City Council Memorandum

Subject: Proposed Staff Clarifications and Responses to City Council Requested Changes to Draft LUCE

Proposed Staff Clarifications and Responses to City Council Requested Changes to Draft LUCE July 1, 2010

20. Delete Exhibit B #89: Change land use designation for Santa Monica Boulevard between 20th and 19th Streets from General Commercial to Mixed Use Boulevard Low (Chapter 2.1 Land Use Policy)

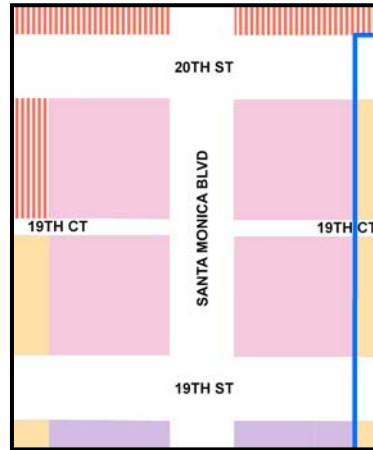
Council Comment: City Council appeared to agree with staff recommendation to allow Santa Monica Boulevard between 19th and 20th Streets to remain General Commercial (deletion of Exhibit B #89)
